# Part 573 Safety Recall Report

# 23V-683

## Frequently Asked Questions (FAQs) for Safety Recall N232420460 B-Pillar Trim May Interfere with Roof Rail Airbag Deployment

## N232420460 B-Pillar Trim May Interfere with Roof Rail Airbag Deployment

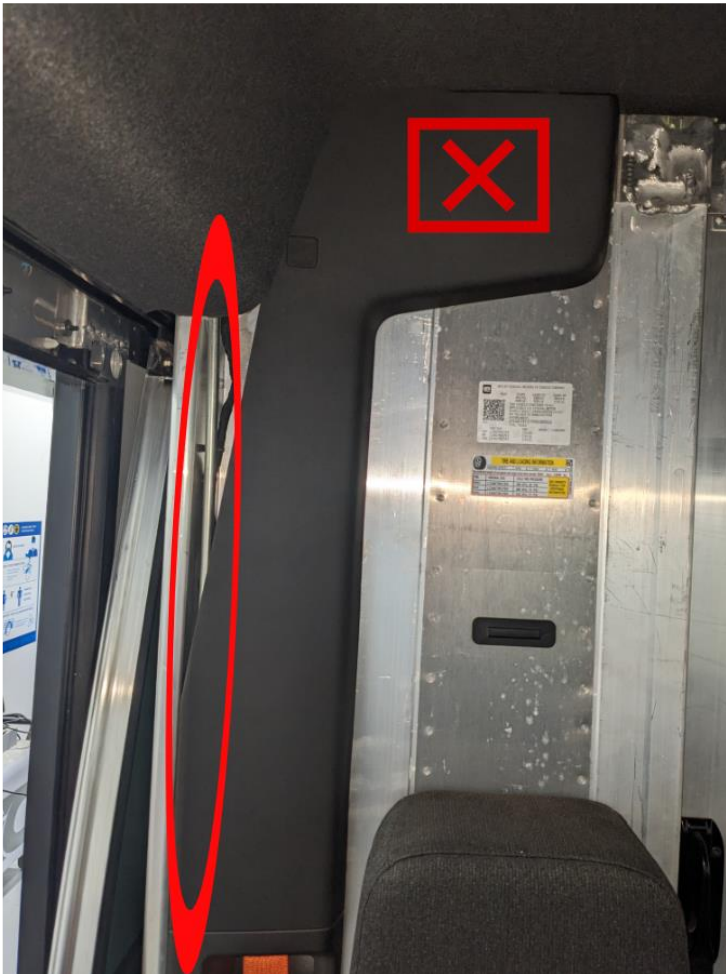
1. Inspect the B pillar trim panel on the passenger's side to determine if it is the correct variant per the above pictures.
  - If the B pillar trim panel is diagonally trimmed in the top left corner AND the airbag rail is visible all the way down to the bottom of the seatbelt bezel portion of the trim panel, no further action is required.

- i. The B pillar trim panel is diagonally trimmed in the upper left portion, but the airbag rail is NOT visible all the way down to the bottom of the seatbelt bezel portion of the panel.

- ii. The B pillar trim panel not trimmed at all in the upper left portion, and the airbag rail is not visible at all.
    - iii. The B pillar trim panel is diagonally trimmed and the airbag rail is visible, but only to the TOP of the seatbelt bezel portion of the panel.

- If the B pillar trim panel has any of the following conditions, replace it. Refer to *Center Pillar Upper Trim Panel Replacement - Right Side* in SI.
